Access Compliance Report

Public Rights-of-Way

(Curb Ramps)

Intersection ID: 10027508	Main Street: GRANDIFLORA_DR	Cross Street: N/A	Location: NE
ADA ID: 82D2536C98C2	Ramp Type: PerpDiag	Initial Pass/Fail: Fail	Overall Compliance: No
Severity Score: 8.75			
Codes/Mitigation Info/Possible Solution		Field Measurements/Component Compliance

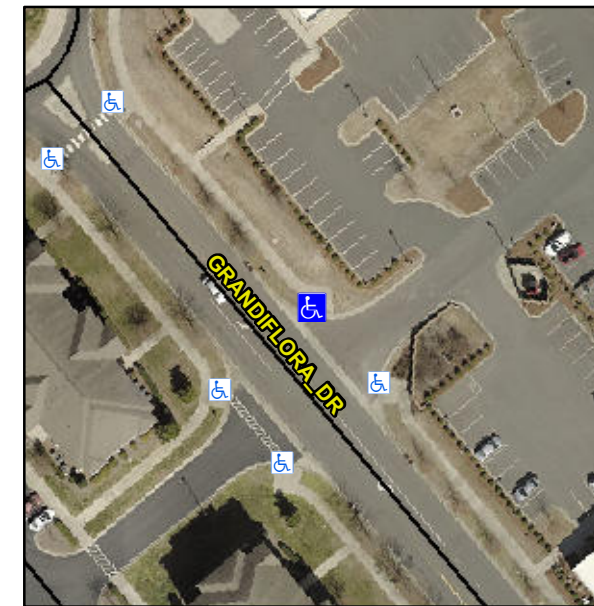
R304.5.1

Compliance	Description	Data	Compliance	Description	Data
N/A	Ramp Length (in)	96.5	Yes	Ramp Slope (%)	6.1
No	Ramp Width (in)	45.5	Yes	Ramp XSlope (%)	0.8
N/A	Flare Type LT	N/A	N/A	Flare Type RT	N/A
N/A	Flare Slope LT (%)	N/A	N/A	Flare Slope RT (%)	N/A
N/A	Flare Traversable LT?	N/A	N/A	Flare Traversable RT?	N/A
N/A	Landing Length (in)	N/A	N/A	DWS Provided?	N/A
N/A	Landing Width (in)	N/A	N/A	DWS Contrast?	N/A
N/A	Landing Slope (%)	N/A	N/A	DWS Length (in)	N/A
N/A	Landing X Slope (%)	N/A	N/A	DWS Full Width?	N/A
N/A	Landing Curb? (Y/N)	N/A	N/A	DWS Offset (in)	N/A
N/A	Shared Landing?	N/A			
N/A	Gutter Ponding?	N/A	N/A	Gutter Slope (%)	N/A
N/A	Gutter Lip Ht (in)	N/A	N/A	Gutter X Slope (%)	N/A
N/A	Painted X Walk1?	No	N/A	Painted X Walk2?	No
	X Walk 1 Direction	To SW		X Walk 2 Direction	To SE
N/A	X Walk 1 Width (in)	N/A	N/A	X Walk 2 Width (in)	N/A
	X Walk 1 Slope (%)	2.1		X Walk 2 Slope (%)	1.1
	X Walk 1 X Slope (%)	0.6		X Walk 2 X Slope (%)	1.2

Remove & Replace Curb Ramp With Two New Directional Ramps or Equivalent.
